Town of Arlington

**FINAL
REPORT**

**ADA Self-Evaluation
(as basis for Transition Plan)**

Prepared by
Institute for Human Centered Design
December 15, 2014

Point of Entry

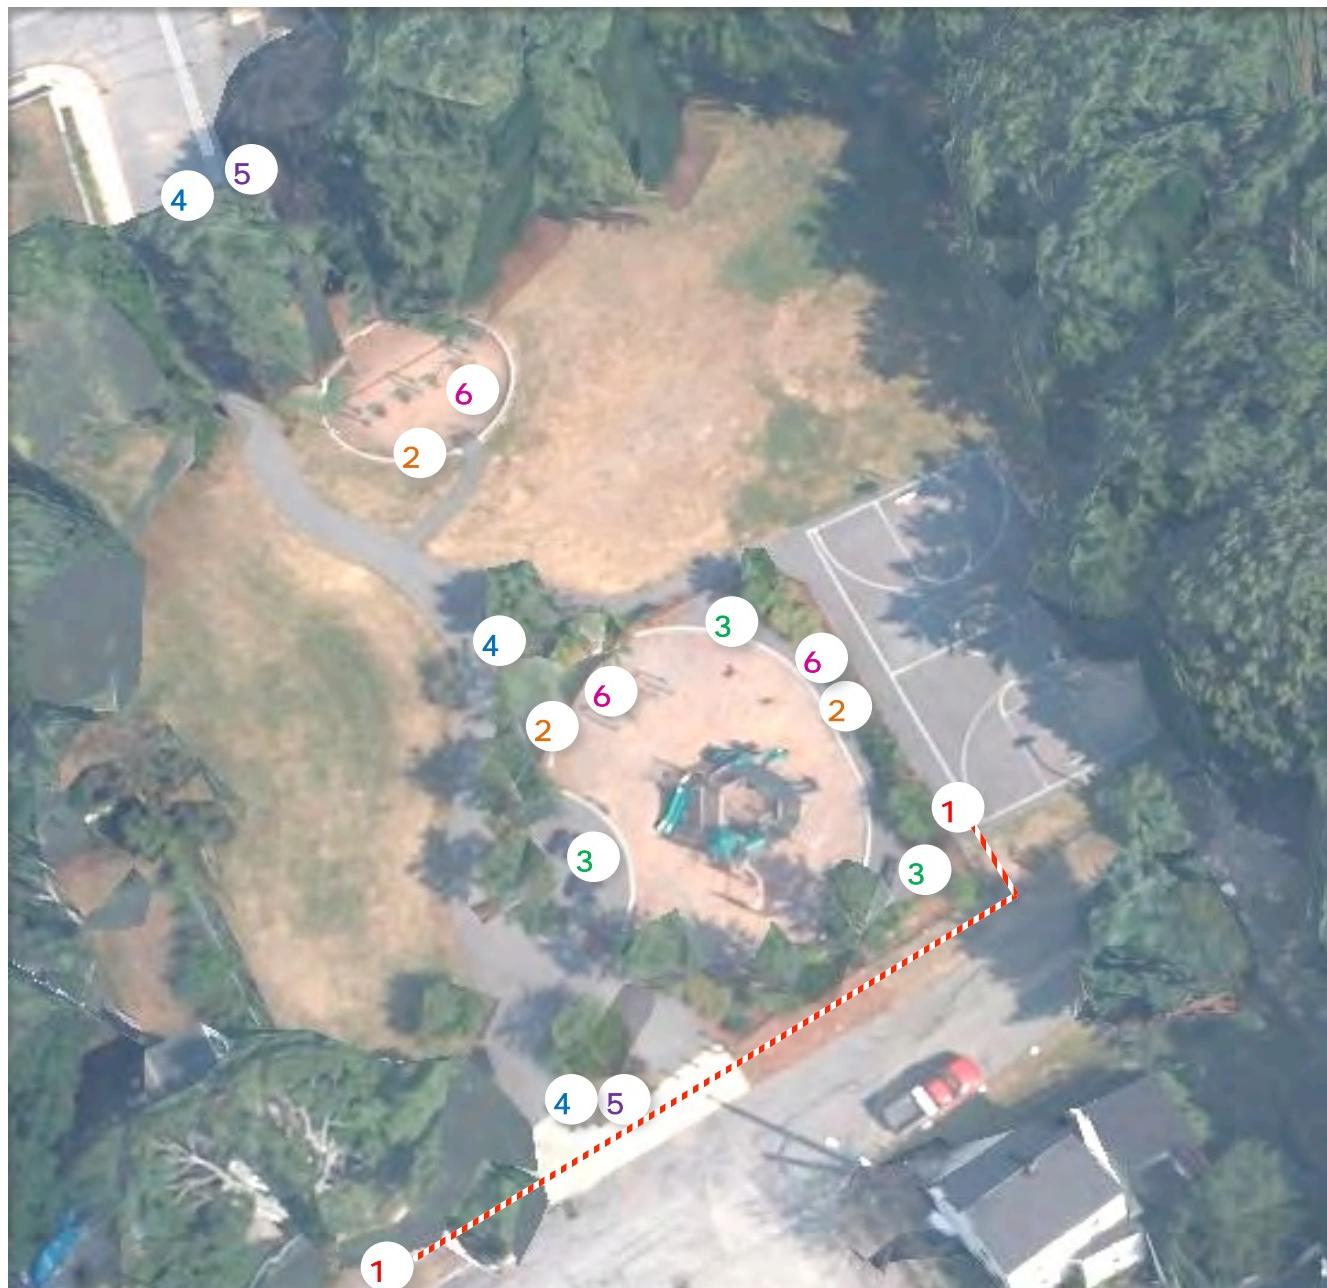
When interior accessible route is reconstructed, regrade entrance design area as well, ensuring that compliant cross slopes are provided in all directions.
